SEWERLINE RELOCATION FROM 9TH AVENUE TO DUNLAP AVENUE
WITH INVERTED SIPHON AT DUNLAP AVENUE

ARIZONA CANAL DIVERSION CHANNEL

CONTRACT NO. FCD 87-27

AUGUST 17, 1987

EXHIBIT A

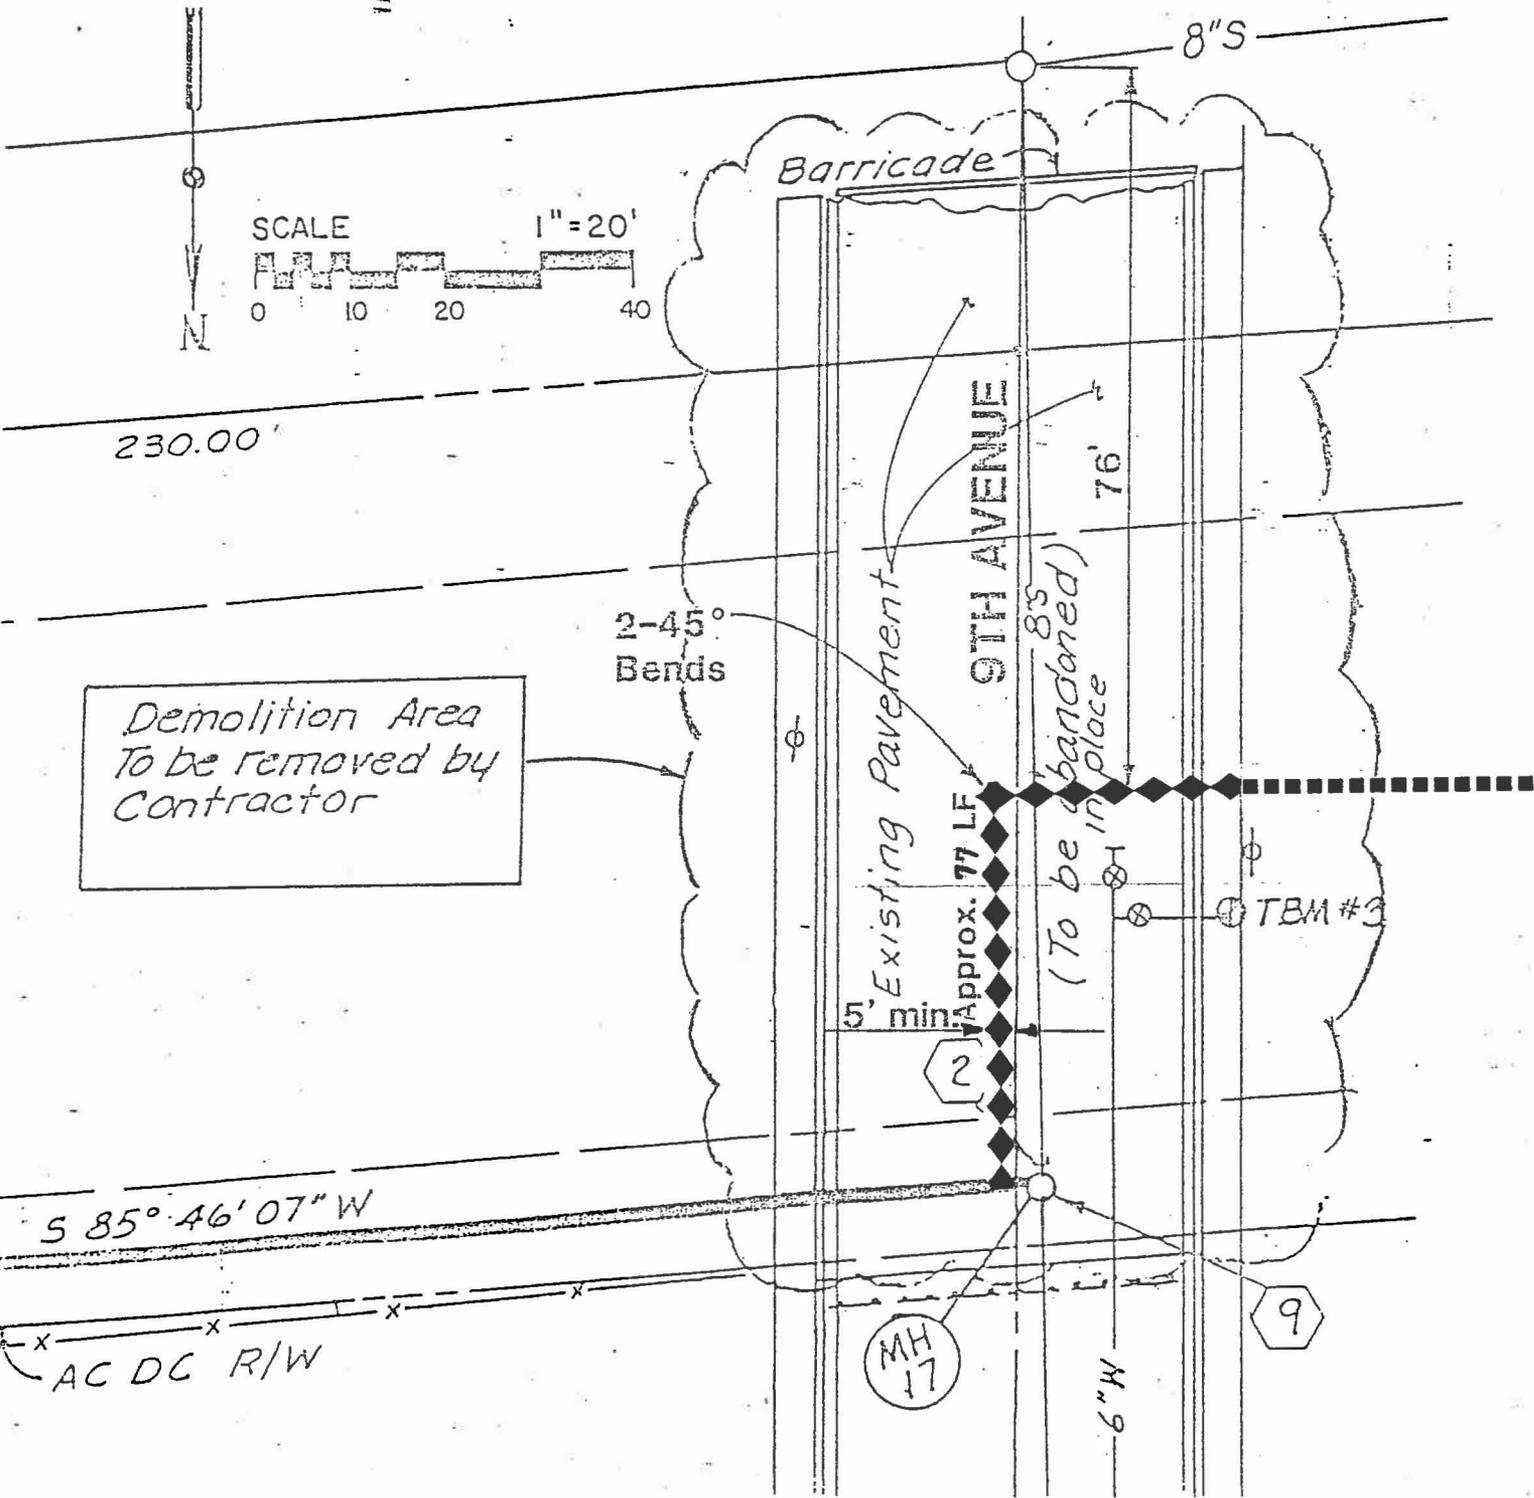
SP-F20 9th Avenue Sewer Service Connection. The Contractor shall field locate the sewer service connection on 9th Avenue shown on the attached Exhibit A and determine the size of the service connection and invert elevation into the existing sewer. The Contractor shall provide survey elevations to the Engineer to ensure the service connection can be made by gravity. Upon determining the size of the connection, the Contractor shall make arrangements to furnish and install in accordance with MAG Detail 440, Type A, the sewer connection along the alignment shown in Exhibit A. Payment for this item shall be included in the unit price bid of the 8-inch VCP Sanitary Sewer, Bid Item 615-2.

SP-F20 9th Avenue Sewer Service Connection. The Contractor shall field locate the sewer service connection, on 9th Avenue shown on Exhibit A and determine the size of the service connection and invert elevation into the existing sewer. The Contractor shall provide survey elevations to the Engineer to ensure the service connection can be made by gravity. Upon determining the size of the connection, the Contractor shall make arrangements to furnish and install in accordance with MAG Detail 440, the sewer connection along the alignment shown in Exhibit A. Payment for this item shall be included in the unit price bid of the 8-inch VCP Sanitary Sewer, Bid Item 615-2.
